ADDRESS: 2017 DELANCEY PL

Proposal: Construct rear addition with roof deck and pilot house

Review Requested: Final Approval

MEETING MINUTES
ARCHITECTURAL COMMITTEE MEETING
28 SEPTEMBER 2021

3 REAR ELEVATION DEMOLITION
SCALE: 1/8"=1'-0"

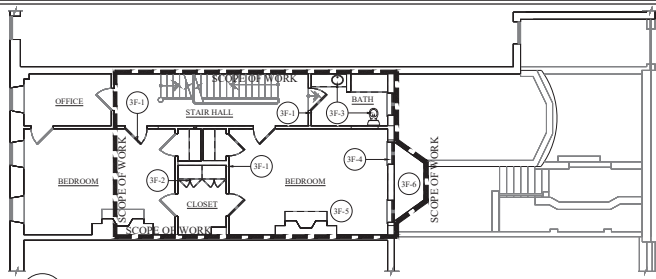
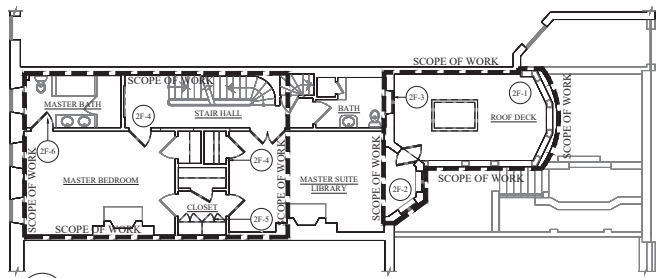
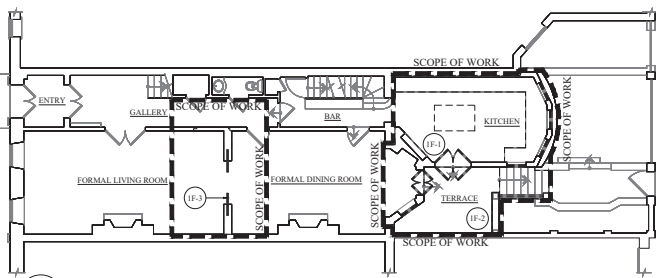
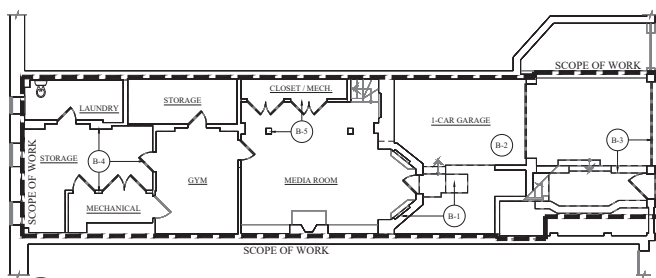
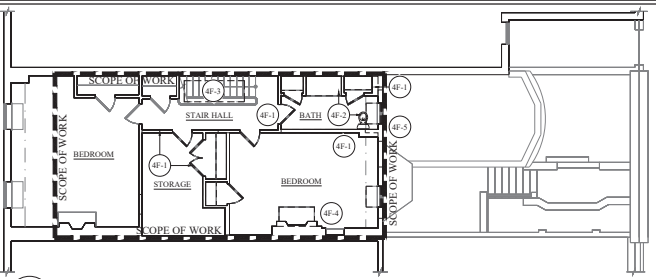
- At the ground level, the new addition proposes to partially demolish and alter non-historic fabric that appears to have been constructed after 1950. However, the scope also includes the demolition of an early two-story rear bay and the existing dormers at the fourth, which does not meet Standard 9.

- The rear addition would alter non-historic building fabric at the ground story; however, the proposal also includes the removal of historic fabric, including a two-story bay, rear wall of the main block, and dormer windows at the rear mansard. The removal of this historic fabric would negatively impact the essential form and integrity of the property.

- Mr. McCoubrey said that he thought it was important to point out the extent of the proposed demolition, calling out the drawings on Sheet 18 that showed essentially removing the entire rear of the third story as well as the entire rear of the mansard. Mr. Detwiler commented that this was really his main concern with the proposal. Mr. D'Alessandro agreed with these comments.

2 PROPOSED ROOF PLAN
A-12 SCALE: 1/4"=1'-0"

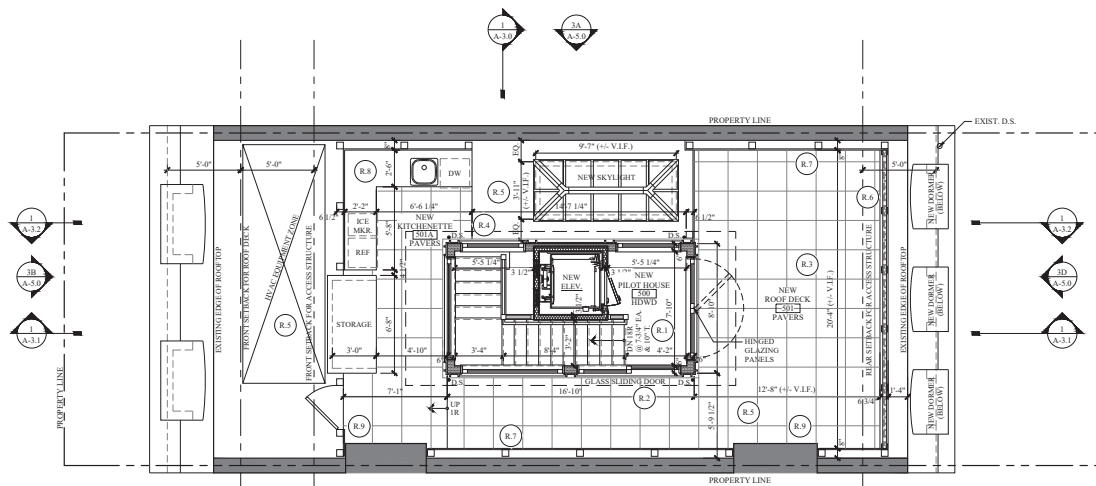
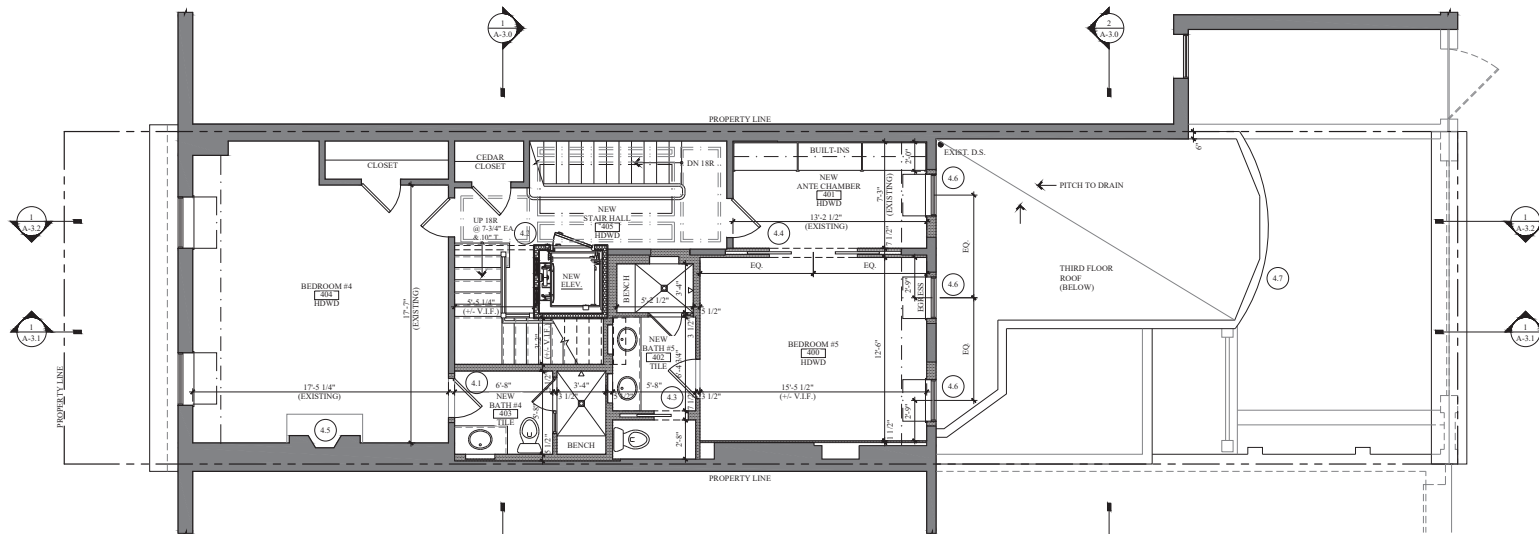
- The mechanical equipment zone would be located at the front of the roof. The staff has concerns about the visibility of this equipment from the public right-of-way.

- The new roof deck and pilot house would be located on the roof of the main block of the house. The staff typically recommends that new roof decks are located off of the main block so that the essential form of the property is not adversely impacted.

- Ms. Gutterman said that she agreed with Mr. Detwiler. She added that she also had concerns about the new addition encompassing the masonry wall at the rear façade, the proposed demolition of the dormers, and the visibility of the proposed roof deck and pilot house, especially from Delancey Place. Ms. Gutterman said that the placement of additional roof deck and mechanical equipment at the front of the roof, as well as the size of the proposed pilot house, concerned her.

- Mr. McCoubrey added that often they do not recommend approval of any roof deck on the main block of a building.
- Ms. Gutterman and Mr. Detwiler asked the applicant to address the location of the mechanical equipment.
